## Addendum No. I

**Project:** West Washington 2019 Practice Building  
**Subject:** Addendum No. I  
**Date:** August 13, 2019

**Project No.:** 1920.01

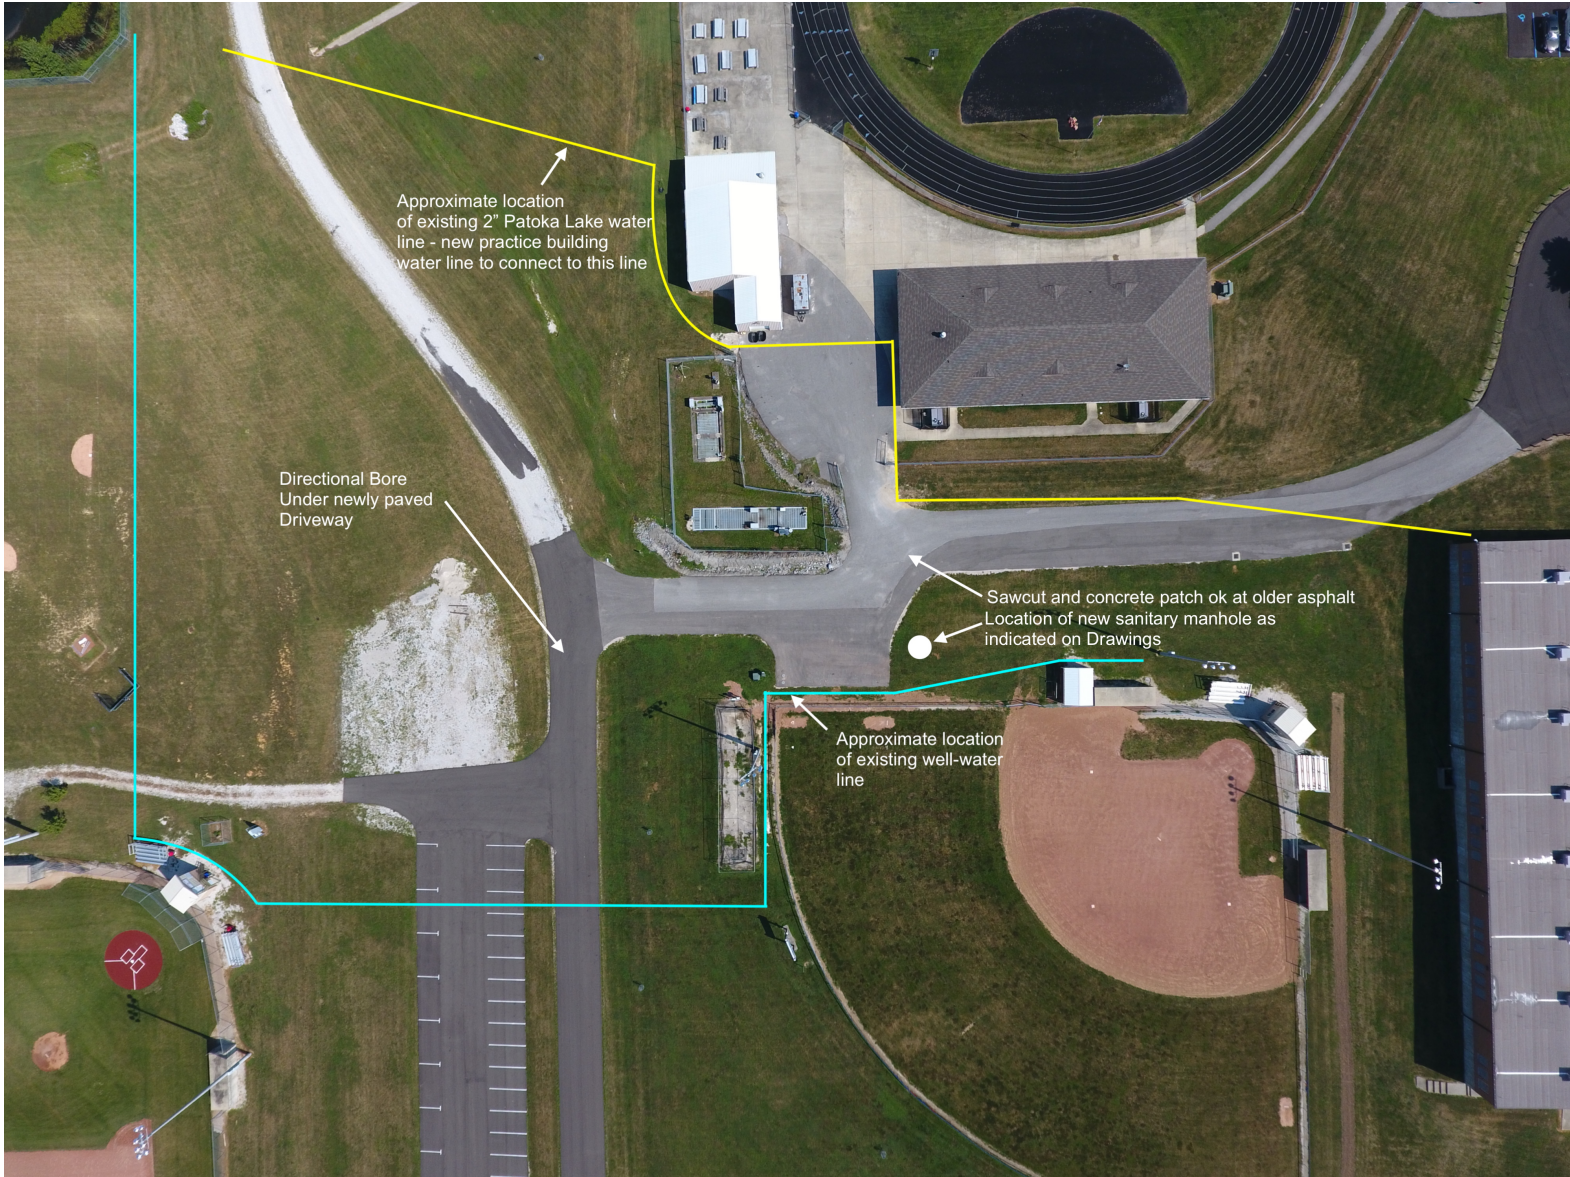
14. The following annotated site aerial photograph clarifies existing conditions as of August 2019, and indicates the location of the existing domestic water line. Water service for the new building is to connect to the existing 2" Patoka Lake water line, not the well water irrigation line.
